REFERENCE	BT_2010_FR20_05_UK
DATE	5th March 2010
SUBJECT	Mandatory updates
PART	Switch plate, clutch shaft, chassis loom, fuel tank tower, front damper bracket, Omega, driveshaft outer joint yoke, upper flap support

Omega sticker

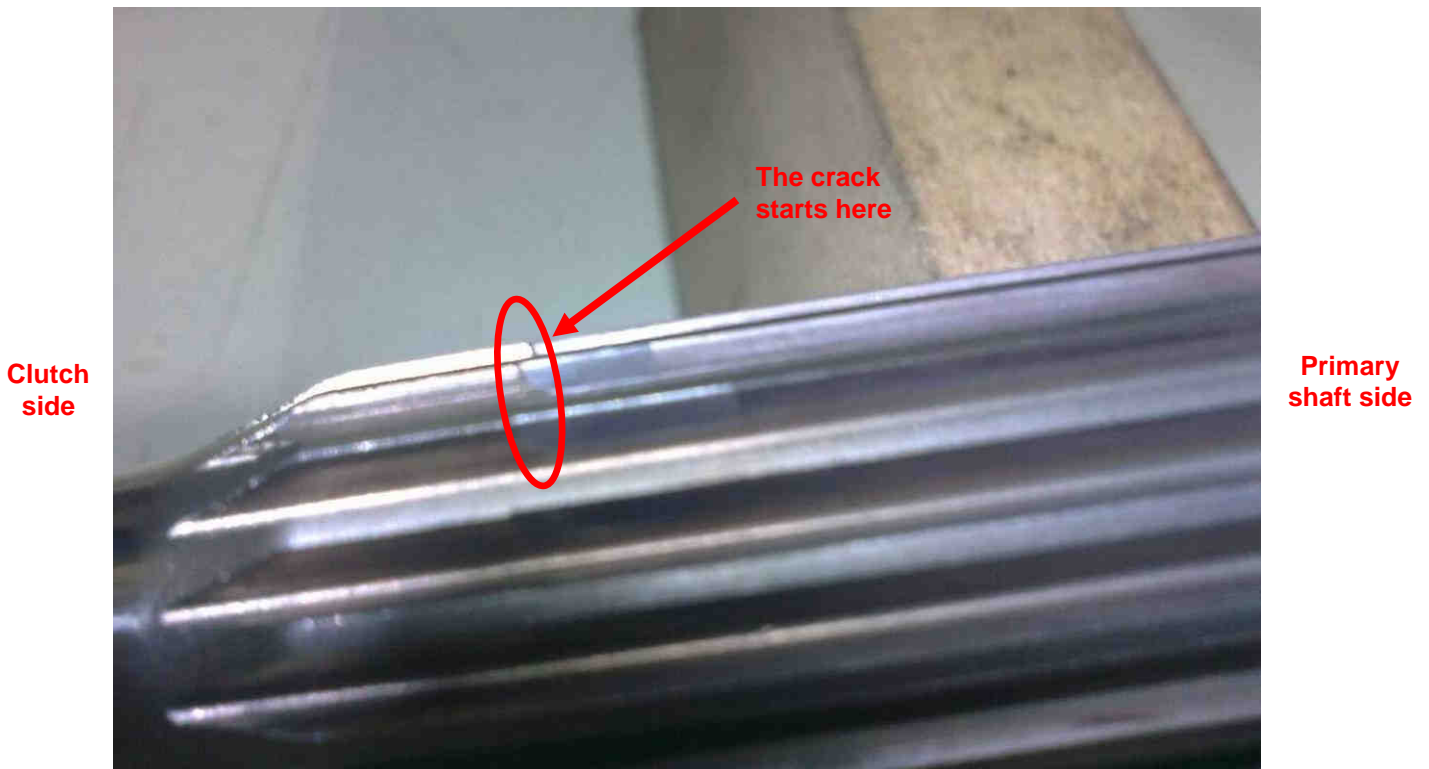
The following sticker must be present on all the Omega data loggers as it certifies the Omega software release which is in the box:

The first cars were delivered without this sticker so, if you don't have this sticker on your box, please contact the Renault Sport technical support to get one.

Clutch shaft cracking

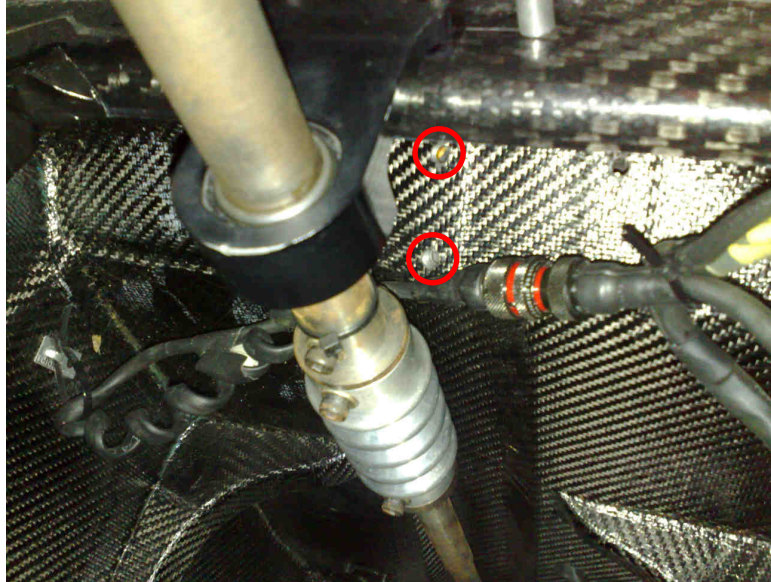
A new clutch shaft will be introduced. In order to use it, the primary shaft will have to be modified. Renault Sport will contact you later to explain the update process and schedule.

As the new parts will not be available before the Motorland tests, we ask all the teams to check their clutch shafts before every session even if they are less than 2,700 km of mileage. For information, please find below a picture of a shaft that started to crack:

Switch plate mounting

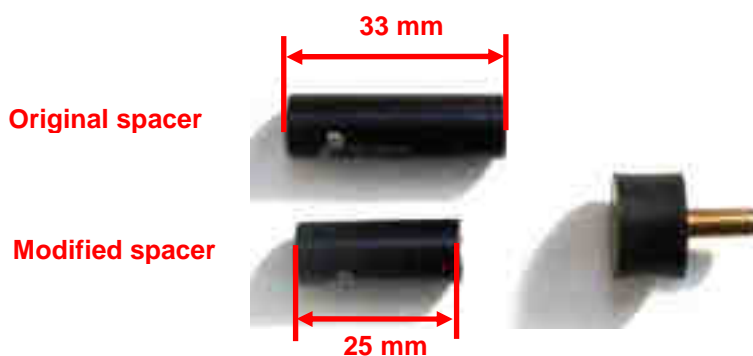
Following several broken wires on the switch plate, we have designed a new wiring specification. New switch plates will be dispatched for free before the first WSR meeting.

In addition to the new switch plates, it is now mandatory to fit the switch plate to the chassis using silent-blocs. These silent-blocs will be available in Barcelona, at the Renault Sport spare parts truck. In order to use these silent-blocs, it is necessary to shorten the spacers and the screws used to fit the switch plate, as shown below:

Fuel tank tower modification

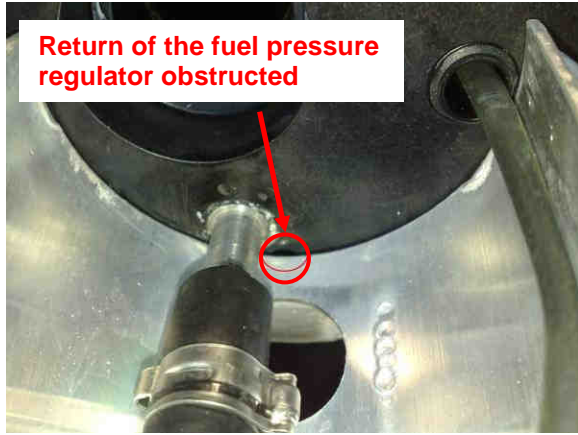
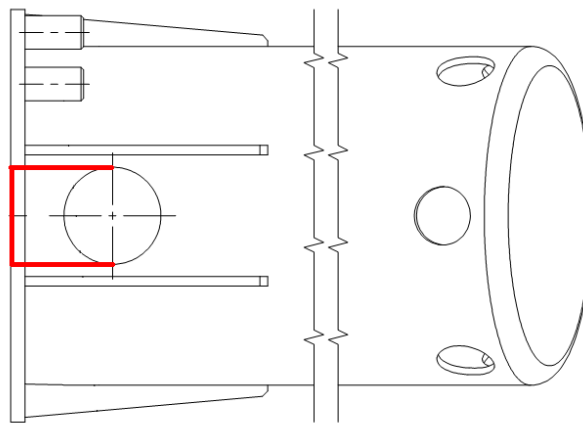
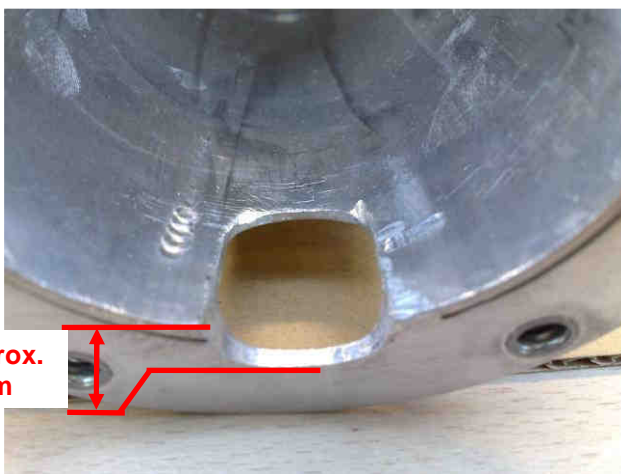
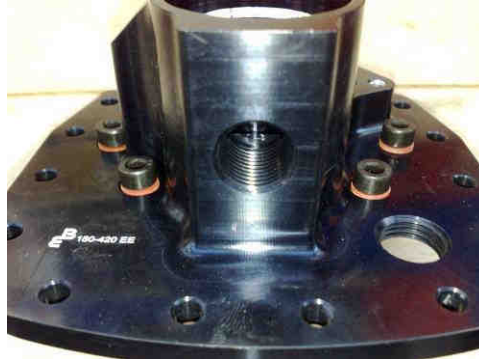
For safety reasons, It is mandatory to modify the fuel tank tower as shown on the pictures below (after Barcelona tests):

Before modification

After modification

Original part: cut line in red

These modifications are already made on all the new cars delivered after the 20th of January.

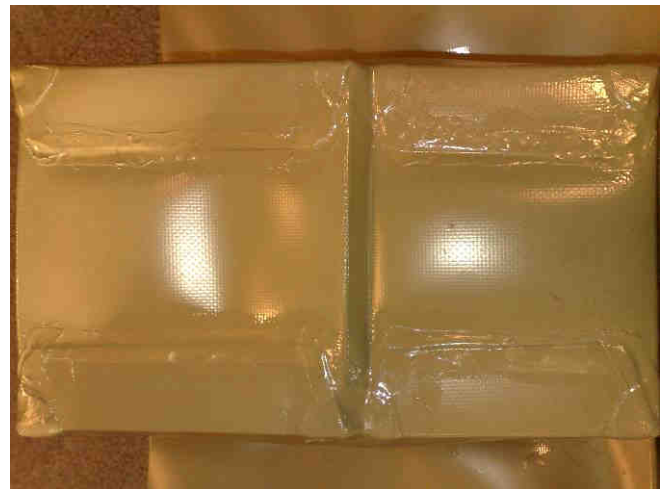
Moreover, it is mandatory to add seals on the screws used to tighten the tower onto the fuel tank cover. On the car delivered after the 20th of January, 4 seals are already mounted:

This modification must be made before Magny-Cours tests. Seals will be available at the Renault Sport spare parts truck at the end of Barcelona test.
